ADDENDUM NO. 1

ELECTRICAL MANHOLE REHAB

Russell Stephenson WRF Project
Okaloosa County Water and Sewer System
Okaloosa County, Florida

ADDENDUM NO. 2

ELECTRICAL SITE PLAN
SCALE: 1/16" = 1'-0"

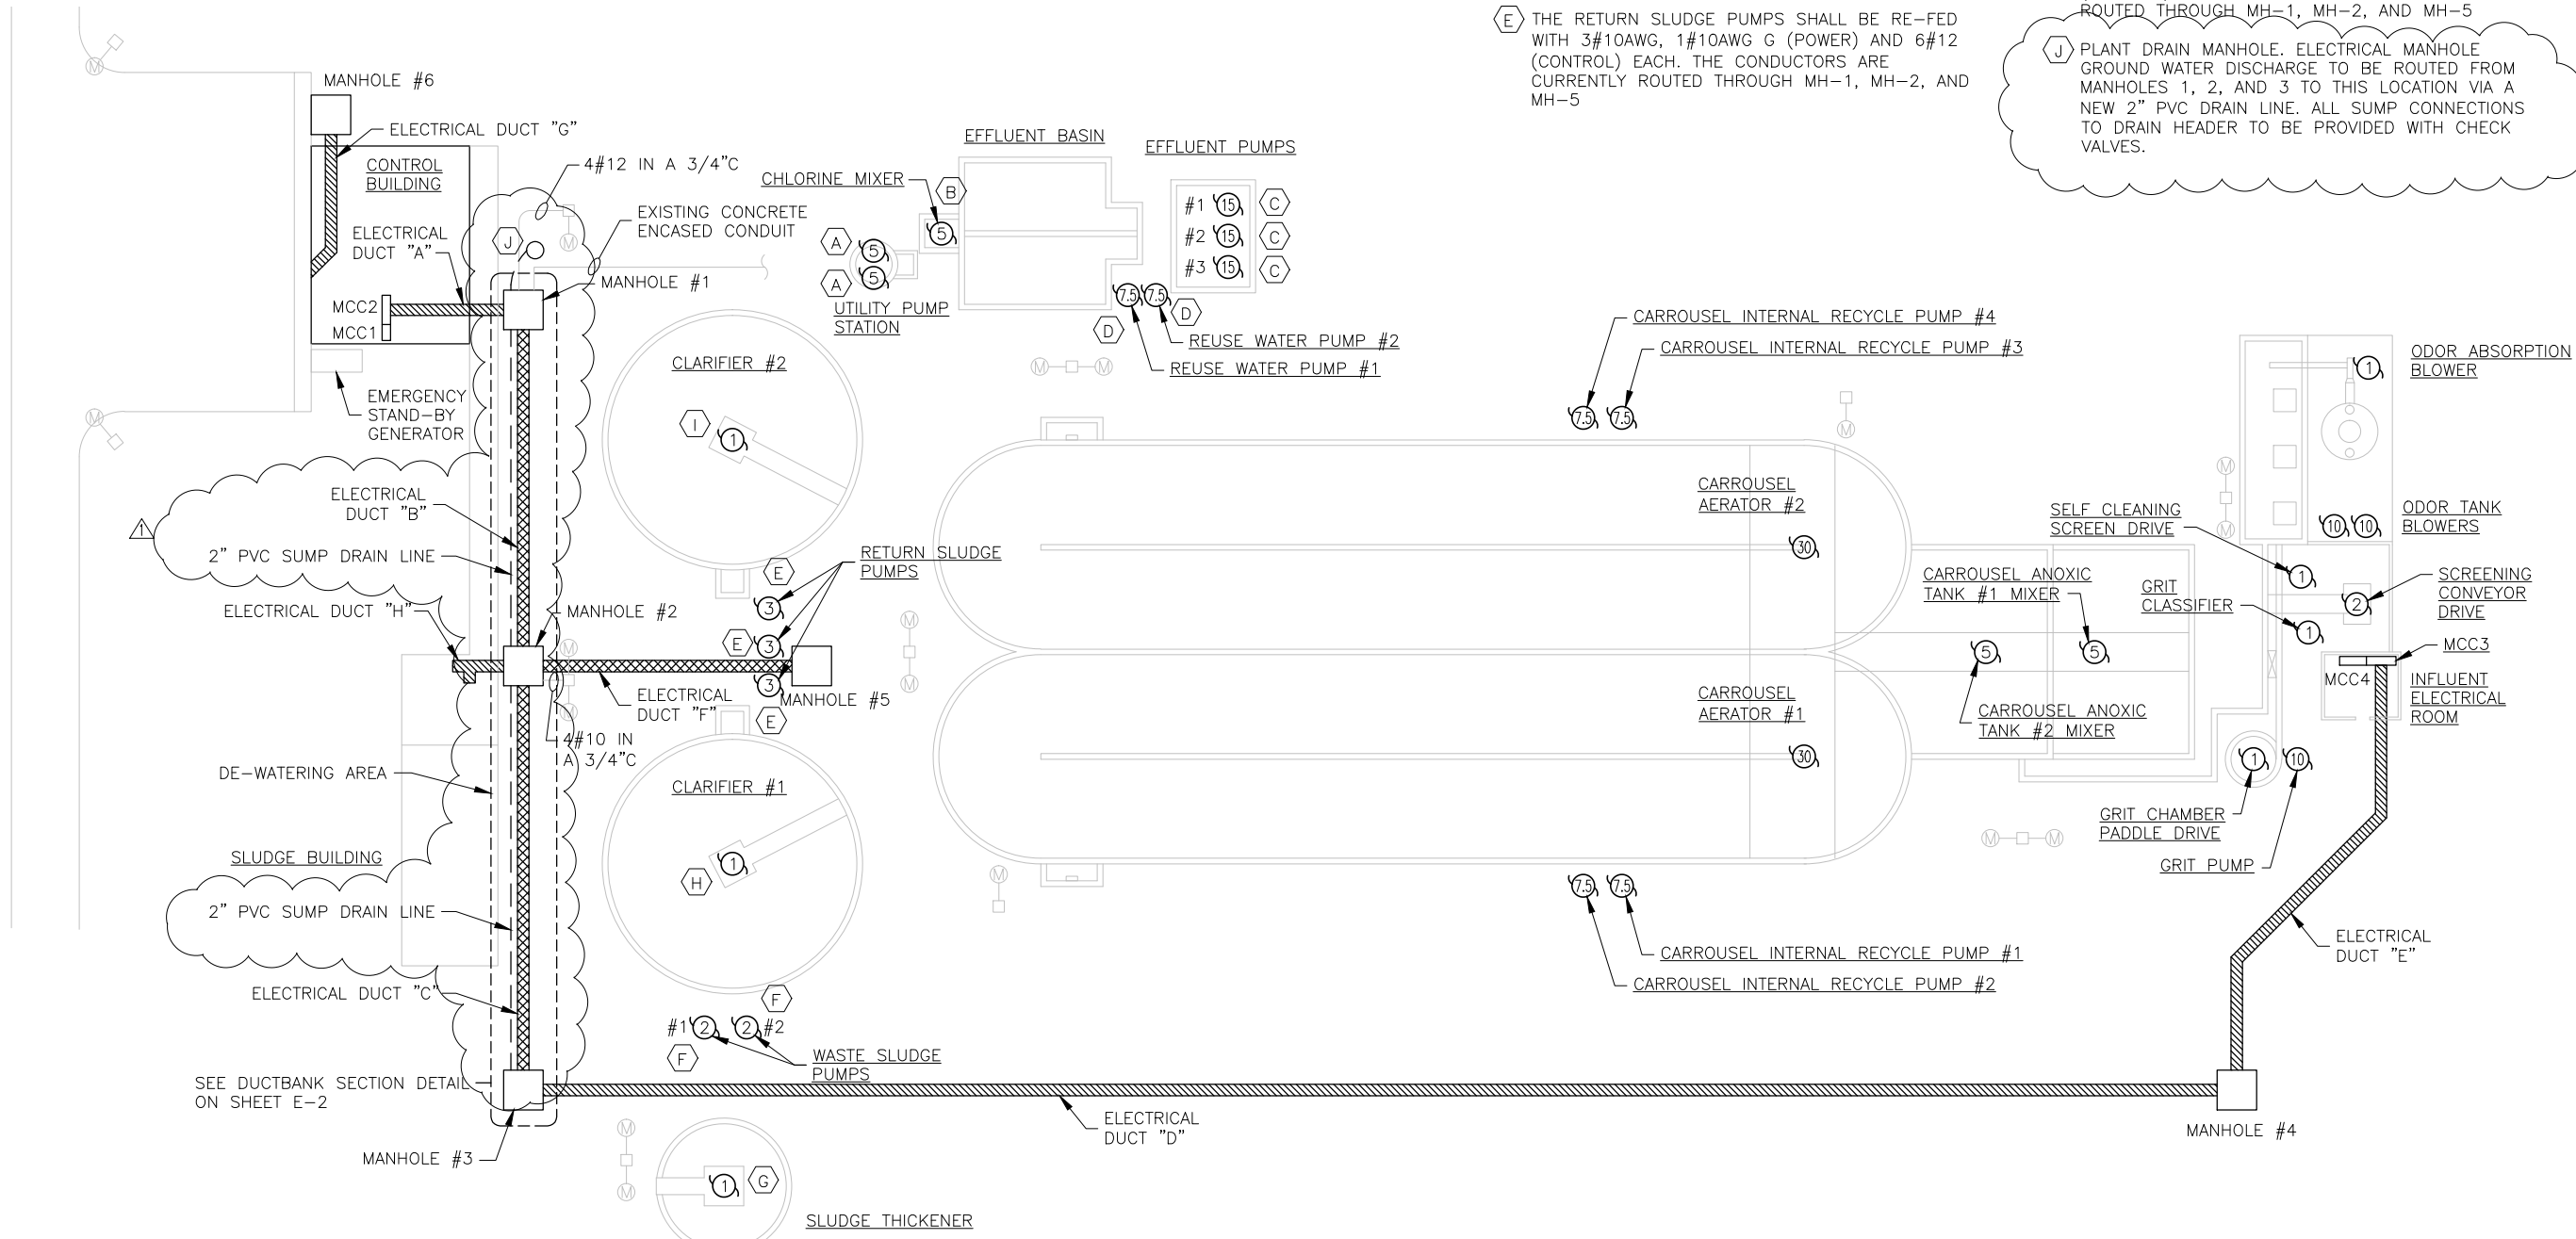
1. Sheet E-4 has been revised to show the location of the new 2" PVC sump drain line. The sump drain line is to be routed underground from each manhole back to the existing site drain manhole located near electrical manhole #1.
2. Sheet E-5 has been updated to show the location of the existing chlorine solution line. The existing solution line must remain in service during construction and shall be required to be supported at a minimum of every 6'. In addition, the sheet has been updated to show the replacement of the following:
 - a. Existing manhole light fixture, conductor, weatherproof cover, housing, and switch
 - b. Existing receptacle, conductors, weatherproof cover, and housing
3. Sheet E-6 has been updated to show the location of the new 2" PVC sump drain header in the conduit and conductor details.

- (J) PLANT DRAIN MANHOLE. ELECTRICAL MANHOLE GROUND WATER DISCHARGE TO BE ROUTED FROM MANHOLES 1, 2, AND 3 TO THIS LOCATION VIA A NEW 2" PVC DRAIN LINE. ALL SUMP CONNECTIONS TO DRAIN HEADER TO BE PROVIDED WITH CHECK VALVES.

RUSSELL STEPHENSON
MANHOLE SECTIONS

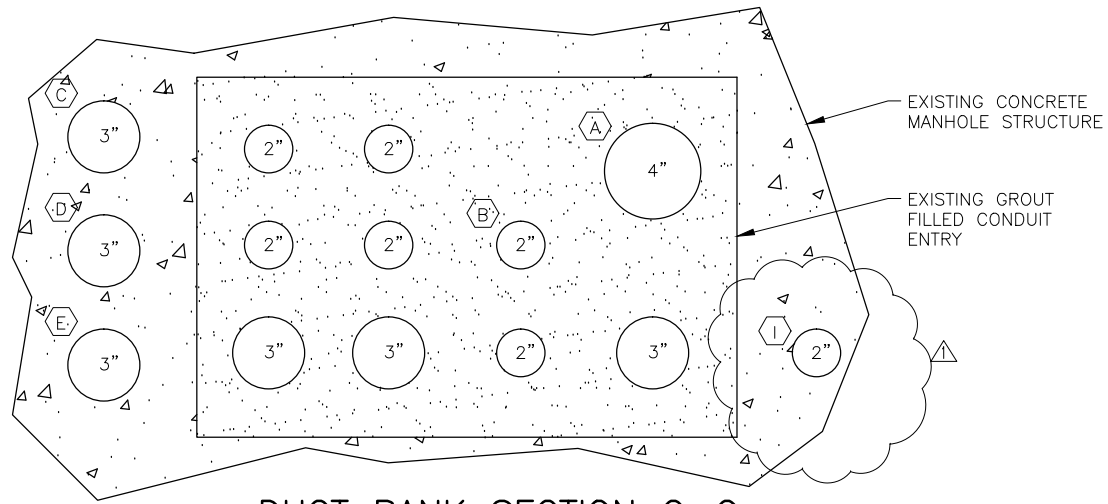
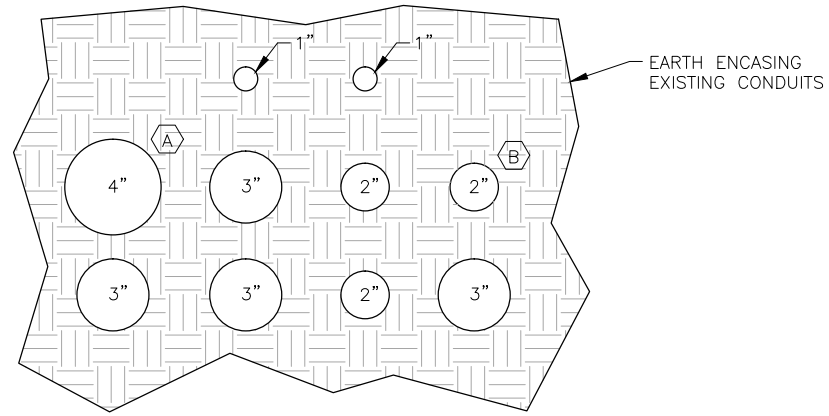
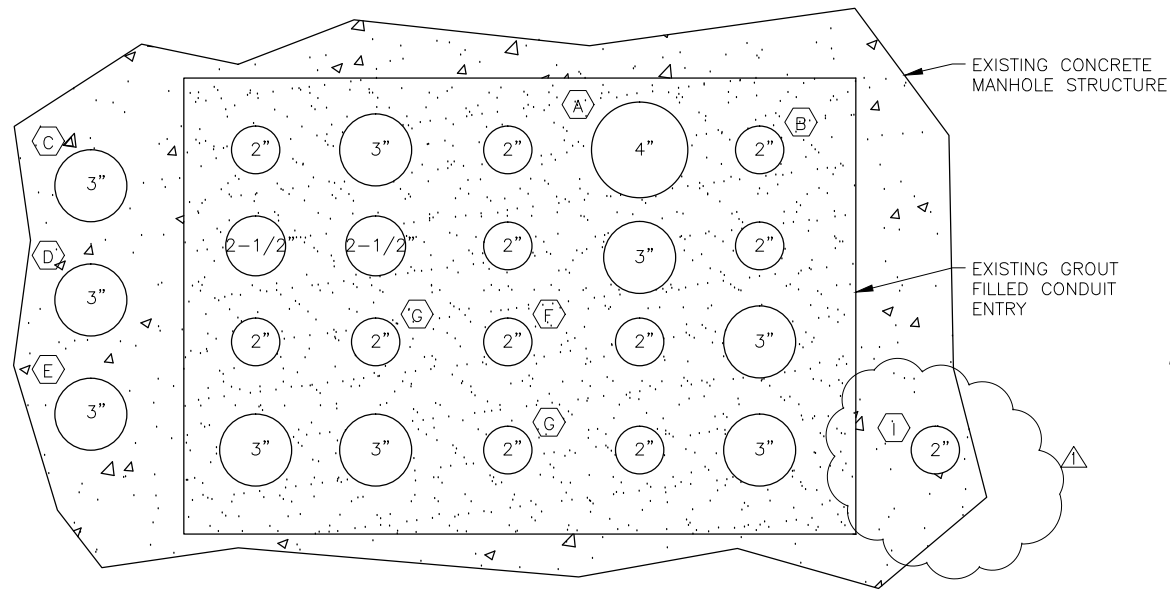
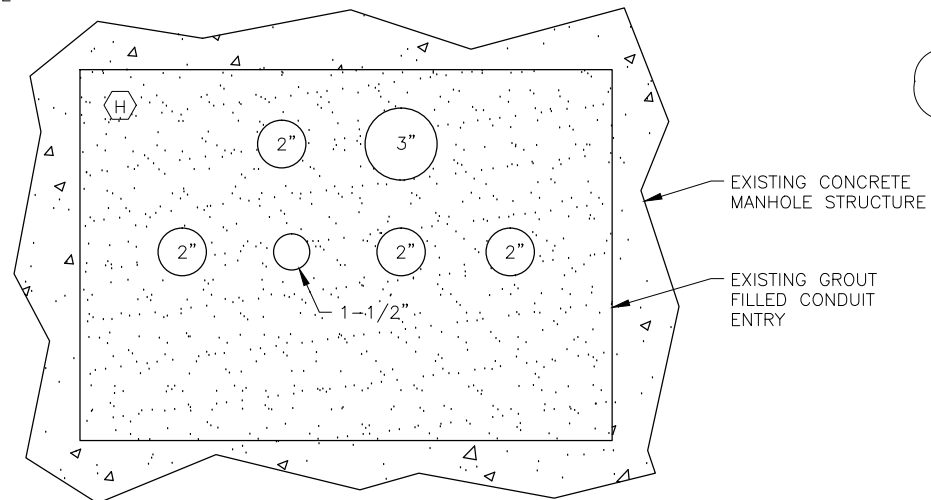
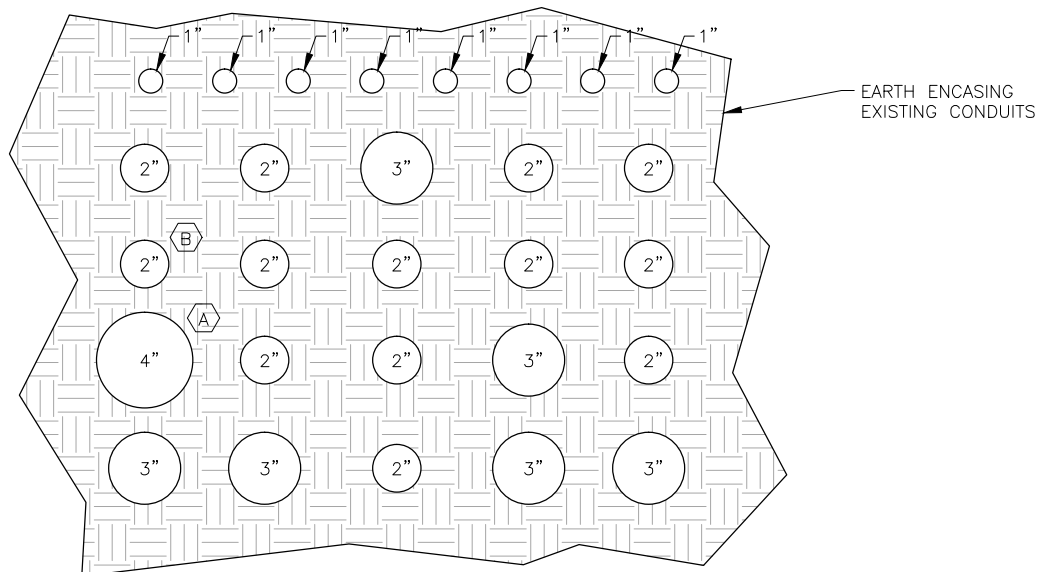
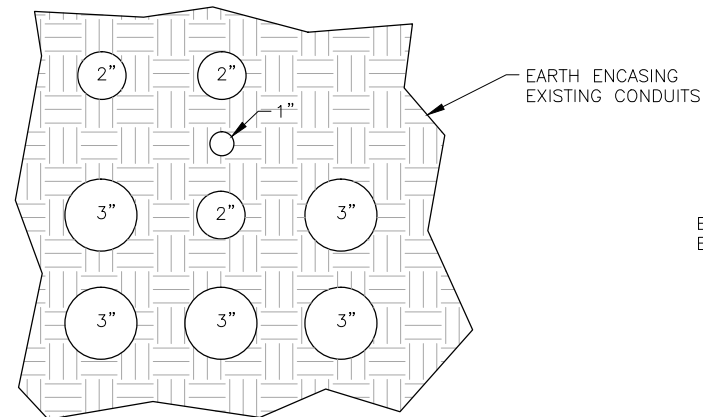
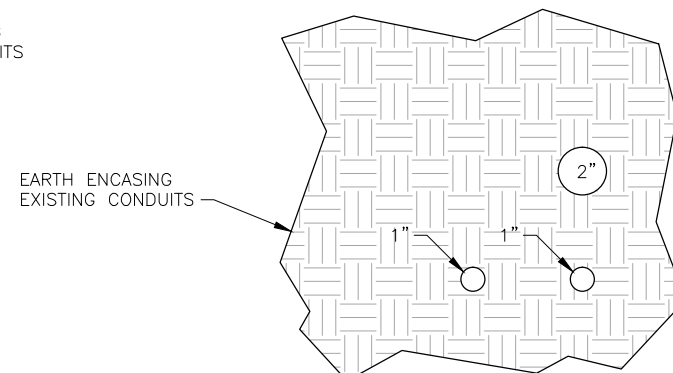
1. Does the installation of the three new electrical conduits encompass all electrical conduits to be replaced under this contract? No. All conduits that have been identified for replacement on sheet E-6 shall be replaced or repaired and shall not be considered as one of the three new conduits that shall be installed. The intent of the three new conduits is to provide the Contractor a means to transition conductors between the manholes to facilitate the staging that shall be required for the installation.
